RE: LODESTONE ENERGY PROPOSED HALDON SOLAR FARM

This document and appendices form part of Transpower New Zealand Limited's (Transpower) review comments in relation to the proposed Lodestone Energy Limited Haldon Solar Farm development at Part Reserve 1358, which is held in Record of Title CB437/82 (**the Site**). The proposed solar farm is a listed project in Schedule 2 of the Fast-track Approvals Act 2024 (FTAA). The project seeks to construct and operate a solar farm across approximately 320 hectares and connect and supply electricity to the national grid. Transpower was provided the following application documents for review:

TRANSPOWER Haldon Solar Farm Site Asset Map

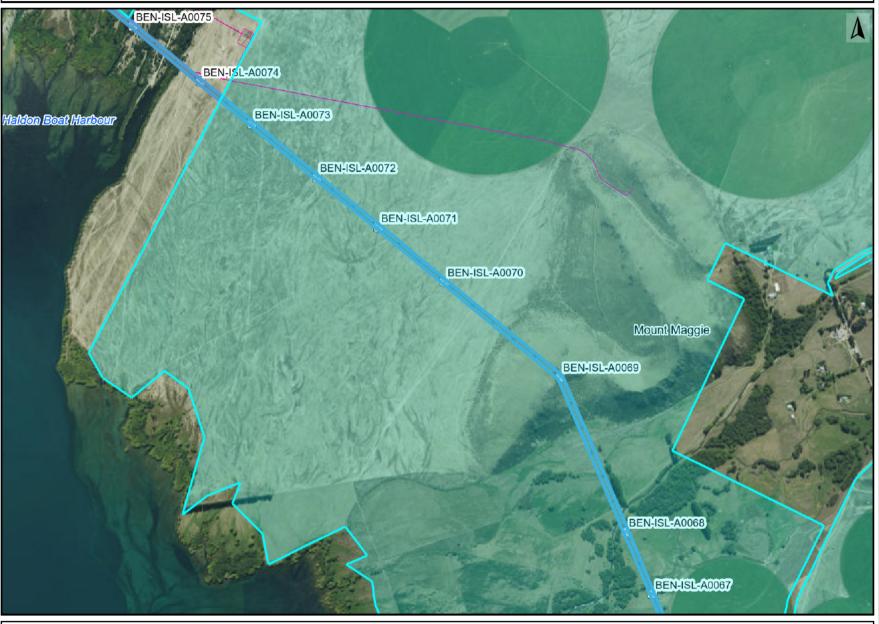
As shown on the attached Asset map (Appendix A), the Benmore to Islington (BEN-ISL-A) 220kV National Grid transmission line traverses the northern half of the proposed solar farm site. Multiple single circuit steel tower National Grid support structures are also located on site (BEN-ISL-A0070, BEN-ISL-A0071, BEN-ISL-A0072 and BEN-ISL-A0073).

Accordingly, the part of the site traversed by the transmission lines is subject to the National Grid Yard (NGY). The NGY is a 12-metre setback either side of the centreline of the transmission line spans supported by towers, and 12 metres from the closest visible edge of all support structures. Please note that the 12-metre setback from the closest visible edge of the support structure foundations is not in Appendix A and will need to be physically measured on site.
